TECHNICAL MEMORANDUM

**RE: ADDENDUM NO. 1
NORTH BOEING FIELD/GEORGETOWN STEAM PLANT SITE
REMEDIAL INVESTIGATION/FEASIBILITY STUDY
SAMPLING AND ANALYSIS PLAN AND QUALITY ASSURANCE PROJECT PLAN
SEATTLE, WASHINGTON**

This technical memorandum presents Addendum No. 1 to the North Boeing Field/Georgetown Steam Plant Site (NBF/GTSP) Remedial Investigation/Feasibility Study (RI/FS) Sampling and Analysis Plan and Quality Assurance Project Plan (SAP/QAPP, Leidos 2014). This addendum provides the revisions associated with the First Amendment to North Boeing Field/Georgetown Steam Plant Agreed Order No. DE 5685 (AO Amendment No. 1).

**Building3-350 and
RI Monitoring Locations**

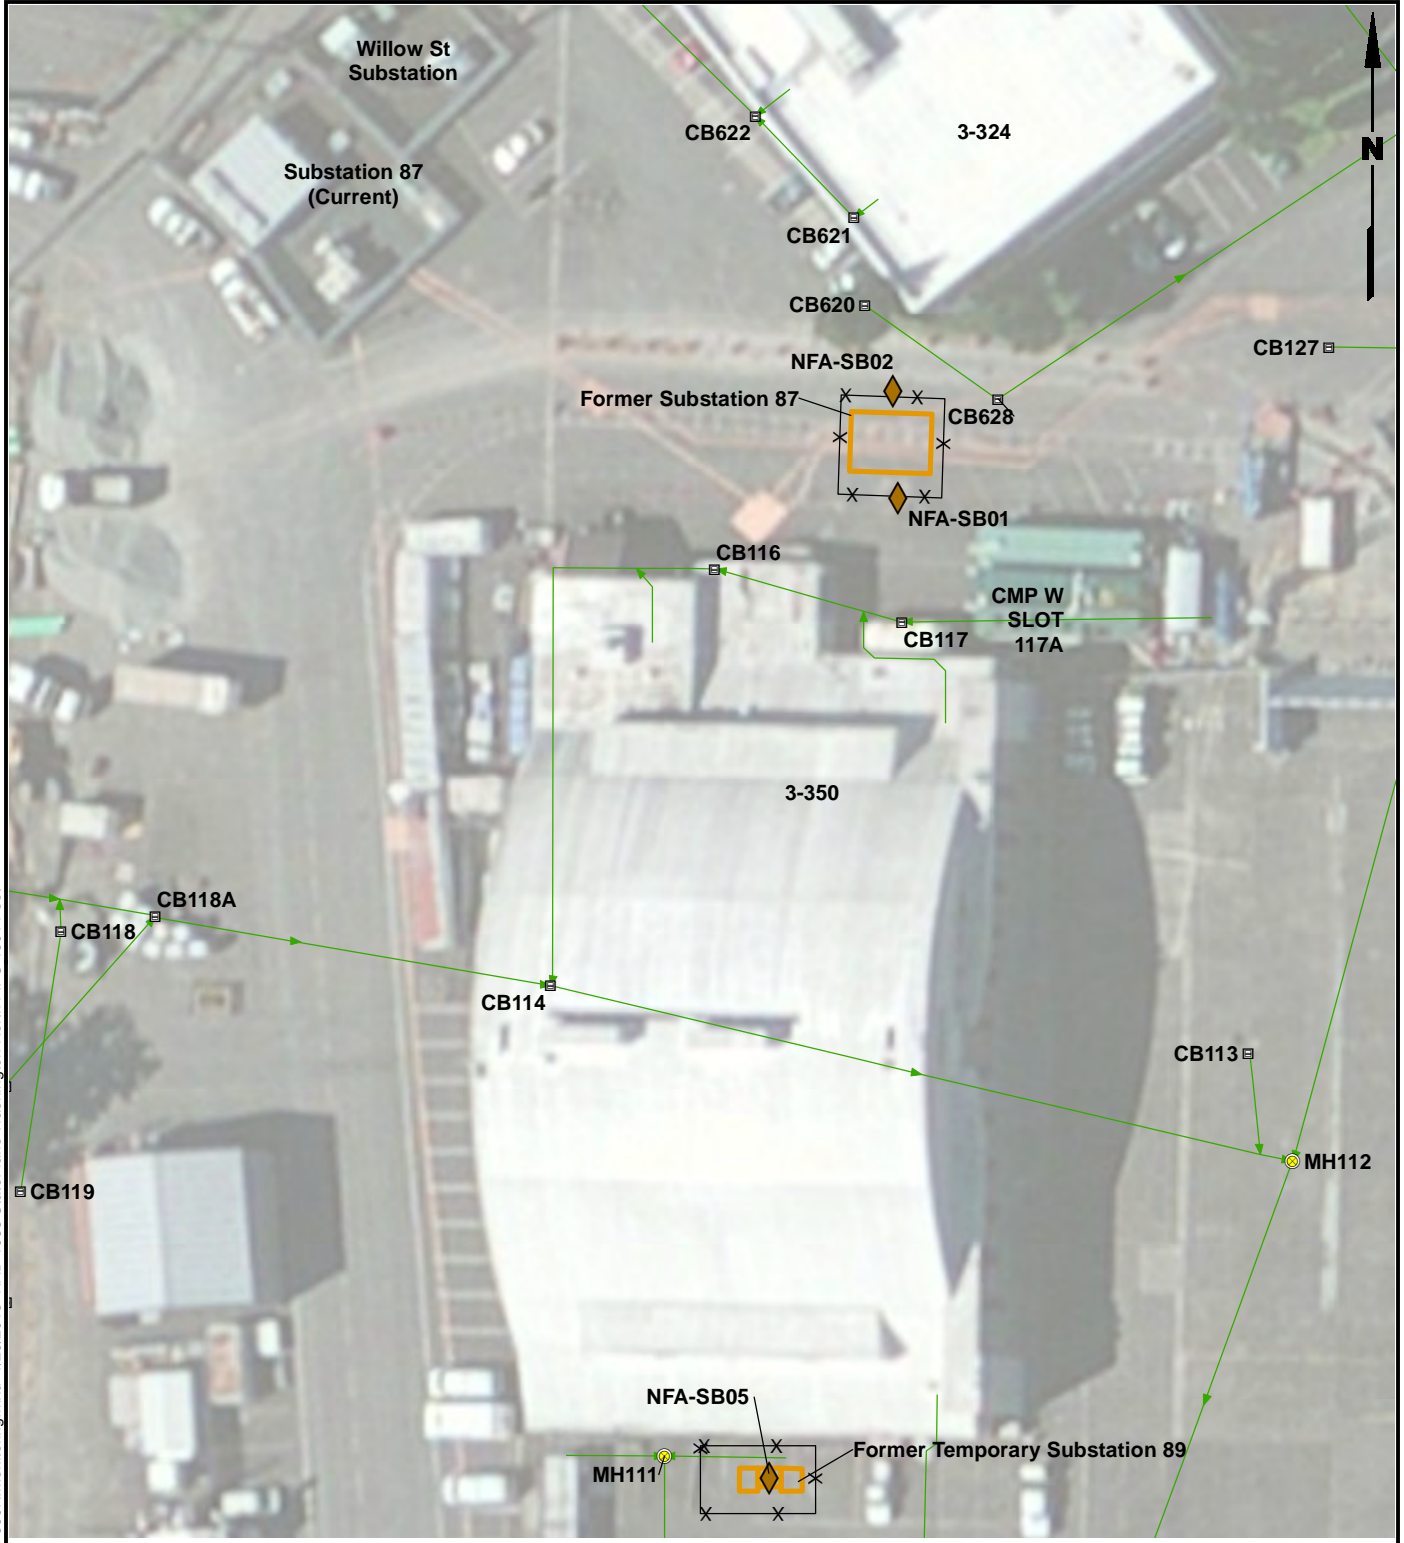
- Building 3-350 soil sampling: Soil sample locations in the SAP/QAPP were based on available information on historical transformer locations. Based on further review of historical photographs and drawings of transformers formerly located near Building 3-350, soil sample locations at two possible transformer areas on the west and northeast sides of Building 3-350 (NFA-SB01, NFA-SB02, and NFA-SB05) are being relocated. The approximate locations of historical transformers, and the relocated soil borings are shown on Figure 1. This change is also reflected in Table 1.
